Re: NHTSA Safety Recall, Campaign number 06E - 019
Detroit Diesel Corp. Campaign number 06C - 4
Van Hool Campaign number 06V - 128
Van Hool Coaches models T2140 - T2145 - S2145 - C2045

SERVICE BULLETIN No.1192

COACH MODEL	: T2f 40, T2145, S2145, and C2045
BULLETIN TYPE	: Safety Recall Program
SECTION	: Section 3 - Drive Train
DATE	: September 1, 2006
SUBJECT	: Detroit Diesel NHTSA recall campaign #06E-019
TERMS & CONDITIONS	: Refer to Detroit Diesel Safety Recall Bulletin 06C-4, which has been attached to this Bulletin.

Subject: **Safety Recall 06C-4**
Series 60 Burst Logic

Baro Harness and Sensor

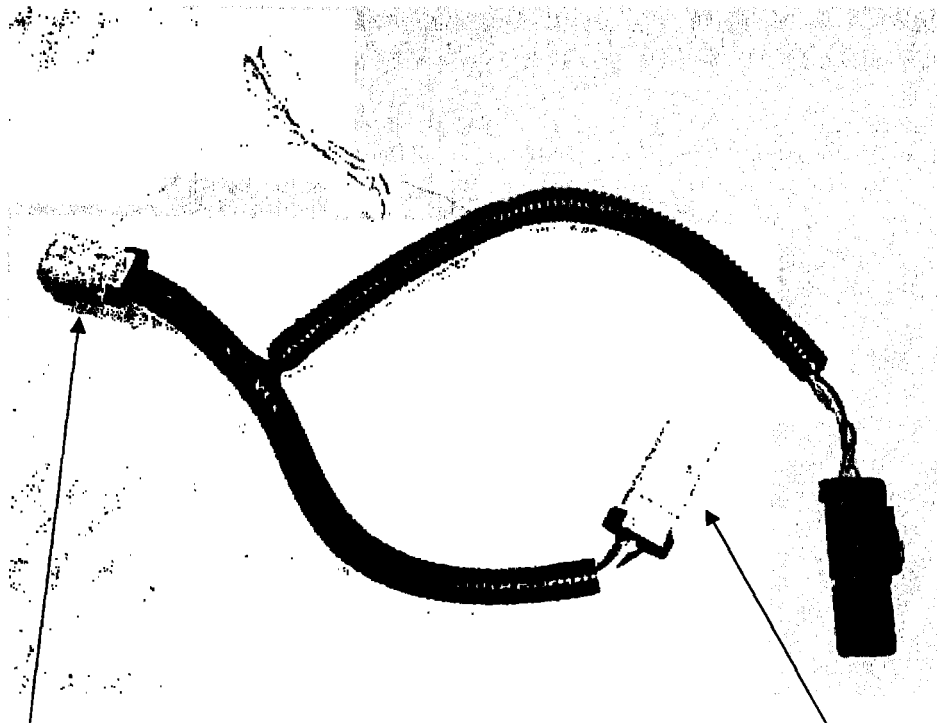
- **Reference** the attached Installation Instructions for installing the Barometric Pressure Sensor and Pigtail Harness (**Attachment I**).

Compressor Wheel Burst Logic with Separate Baro Sensor

Connect to Turbo Boost Sensor

Connect to Sensor Harness Connector

Harness P/N 23536485
Sensor P/N 23527673
